RE: Review of the Sonoita Creek Mitigation Project Proposal for the Proposed Rosemont Copper Mine

Review of the Sonoita Creek Mitigation Project Proposal for the Proposed Rosemont Copper Mine

G. Mathias Kondolf, PhD
2241 Ward Street, Berkeley CA
mattkondolf@gmail.com

29 December 2017

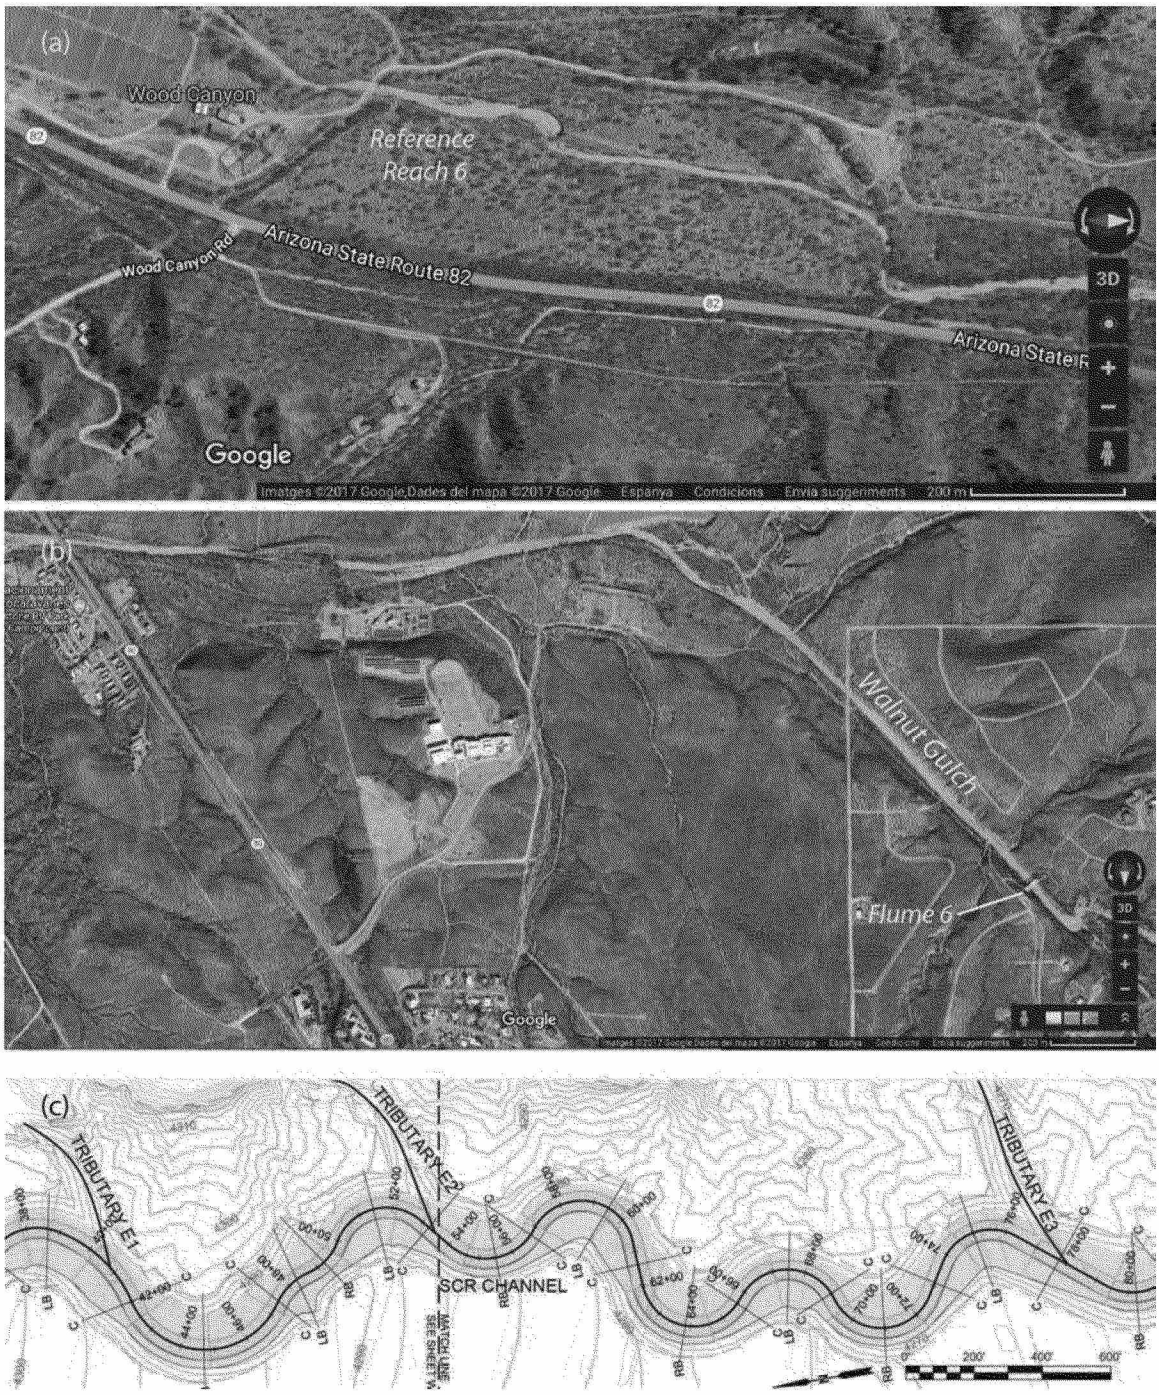
WET (2017:25) states that the reconstructed channel sinuosity "mimics the measured sinuosity of natural, least-altered reaches of Sonoita Creek…Typical values of sinuosity observed in the least altered reaches of Sonoita Creek ranged from 1.1 to 1.4." This statement is not true. The asserted values do not agree with my independent measurements of sinuosity for the existing reaches of Sonoita Creek. For Sonoita Creek in Rail X Ranch, I measured a sinuosity of 1.07; from 'Reference Reach 6' downstream to the point where Sonoita Creek becomes adjacent to Hwy 82, a sinuosity of 1.07 (Figure 1a); and from the end of the Hwy 82 adjacent section to the road crossing downstream of Reference Reach 8, a sinuosity of 1.29. The latter value is exceptional, occurring only in this more sinuous and dynamic reach. The "typical" values are certainly lower, and well represented by the measured 1.07. Sinuosity does not reach 1.4 on these reaches of Sonoita Creek. At the Reference site 6, which was used by WET (2017) as a basis for design of the proposed channel reconstruction, the channel is nearly straight, as reflected in the measured sinuosity of 1.07.

Similarly, WET (2017) also uses Walnut Gulch near Flume 6, in the Walnut Gulch Experimental Watershed near Tombstone, Arizona, as a reference reach (Figure 1b). This reach is almost perfectly straight before going through an approximately 30-degree bend to the left, and thus depending on the length of reach selected, its sinuosity could be as low as 1.0 (taking only the straightaway before the bend), or about 1.07 (including the bend and continuing downstream to the highway bridge). Thus, this reference reach does not provide support for a highly sinuous channel design on Sonoita Creek.

WET (2017:25) states "The restored channels have a sinuosity that ranges from 1.1 to 1.2." This is false. The proposed channel design is much more sinuous than asserted in this statement, much more sinuous than the existing channels in Sonoita Creek, and more sinuous than the reference reaches in Sonoita Creek and Walnut Gulch (Figure 1).

The proposed meandering channel has a sinuosity of about 1.39, as measured from Tributary E1 confluence to the Tributary E3 confluence (Figure 1c). This would be a very large increase in sinuosity over the typical sinuosity of 1.07 prevailing today. This has significant implications for the proposed mitigation project. As discussed below, to build a channel with such an artificially high sinuosity imposed is likely unsustainable, and after a few moderate storms, the result would probably be that the meander bends wash out, leaving a shorter, straighter channel.
